PL/2021/08690 Melksham Solar Farm:
S73 Variation of Conditions- Planning
Statement

September 2025

Project No.: SOL_25_P091_MRY

Figure 3.2 Proposed Layout

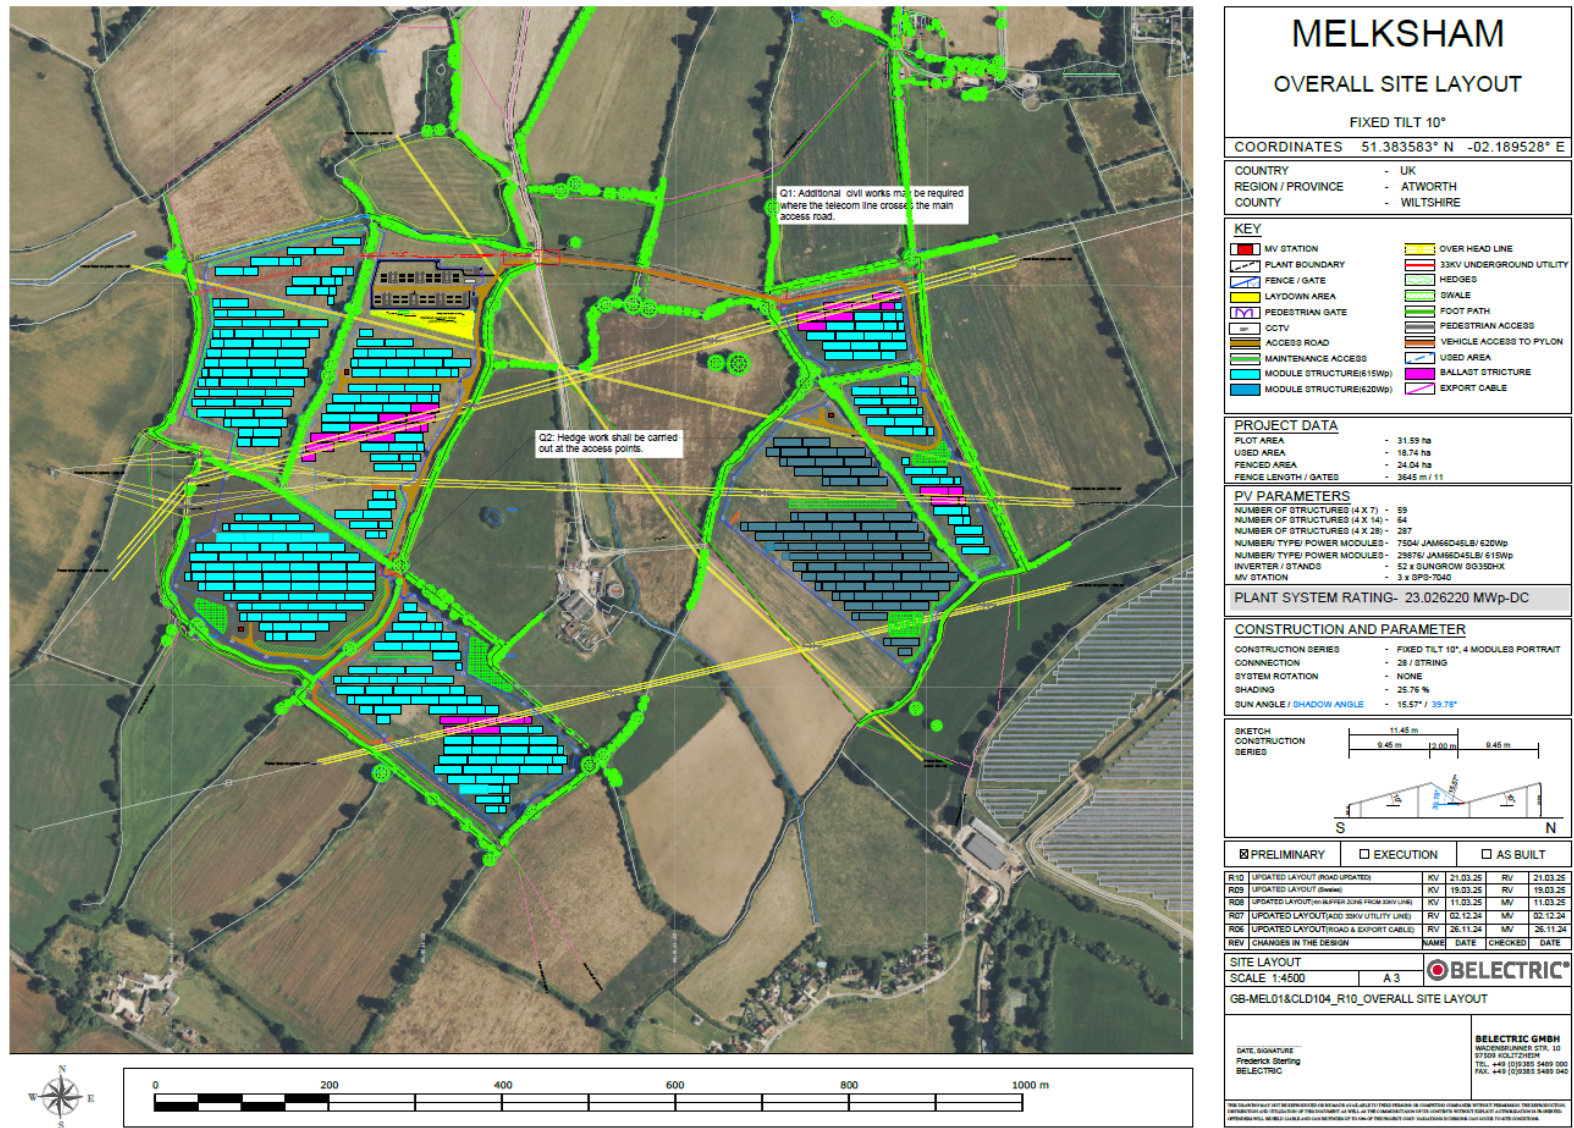
The site's detailed design has resulted in some minor layout changes to the consented site layout which are summarised below:

- Fewer rows of PV panels generally as a 4 panel mounting layout is being proposed rather than 3 panel originally submitted.
- Minor repositioning of security fence to optimise PV panel layout.

- Minor repositioning of some panels to ensure pylon buffer zone is acceptable and for pylons to remain accessible to transmission operators. Addition of 1 gate for access to pylon.

- Panels shaded pink on the drawing are on ballasted foundations due to height restrictions for installation machinery from overhead lines. The panels themselves remain 3m or lower as consented.

- Minor additional sections of access roads to ensure all fields are accessible, which will be subject to a separate minor planning application to be completed.

- PV MV Inverter stations reduced from 6 to 3, and placement optimised.
- Hedge works are required at 3 no. access points outlined in the latest layout drawing and marked in red.

- BESS compound layout has changed to reflect latest technology available. The height of the BESS compound is the same as is consented.
- Terracing of BESS and BESS BoP compound and additional swales in line with revised drainage consultant drawings.

- Inclusion of laydown and site compound area, not included in original submission.

Figure 3.2 illustrates the layout of the site including the proposed changes. Please view the full drawing provided in Annex 1 for detail.

All changes are summarised in Section 3.2. In short, no major alterations have been made to the general arrangement of the site. Fewer rows of PV panels and PV inverter stations are proposed with a reduction in the footprint of the BESS compound and slight repositioning of panels around pylons and associated security fencing.

The blue marked plans should be replaced with the following documentation or removed from the condition:

- Proposed Site Plan, Drawing No. GB-MEL01&CLD104_R10_OVERALL SITE LAYOUT Dated March 2025;
- ~~PV Elevations~~ (elevations are now included within the layout drawing);
